# KLISTOFF EQUIPMENT & MACHINERY, INC.

## Right Angle Spiral Bevel Gear Speed Reducer Dimensional Comparison Sheet

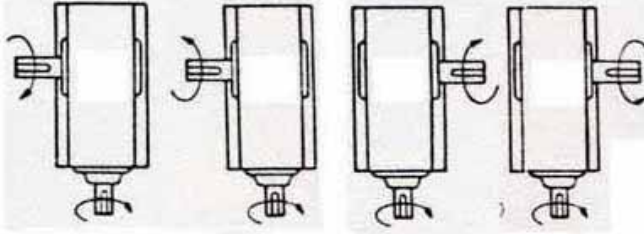
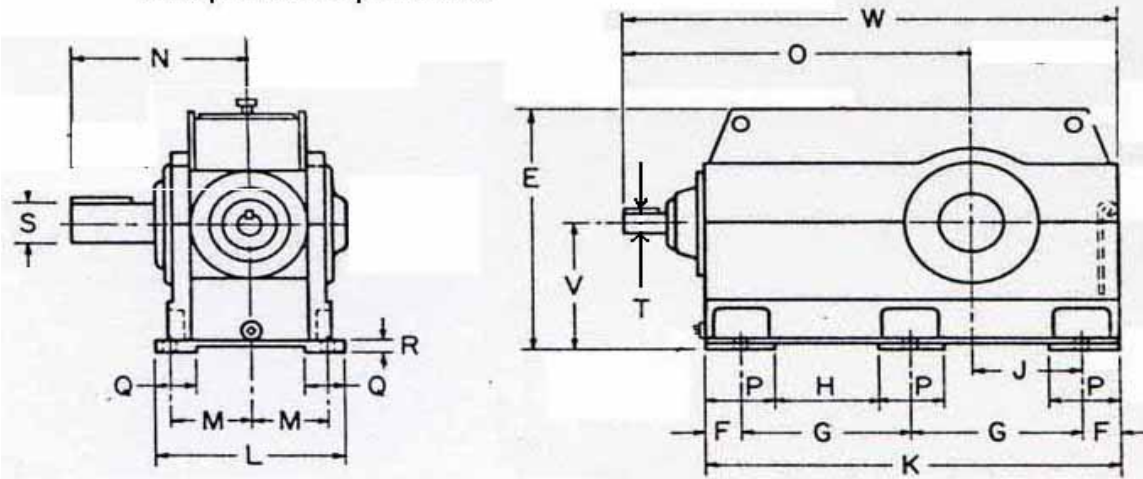
Note: When replacing right angle bevel geared units you will want to be aware of the relative rotations of the input and output shafts.

OBSOLETE UNIT	REPLACEMENT UNIT
Model	2140YB2	RDK33F-BNN 31.5
Ratio	31.70:1	32.72:1
Rating@ 1750_RPM	431 HP	890 HP
Thermal	299	600 HP w/fan
V	22 1/2	17 23/32
G	27 3/4	30 45/64
J	11 1/2	16 17/32
K	65 1/2	66 5/32
L	30 1/2	25 9/16
M	13 3/8	7 15/32
N	28 1/4	29 1/8
O	59 1/4	59 3/8
S	7.250	8.000
T	3.500	3.000
W	83	80 1/8
Weight	7500	8,000

Note: The Falk 2140YB2 is a double reduction, the Hansen is a triple reduction. Output rotation will be opposite, you will have change direction on the motor.
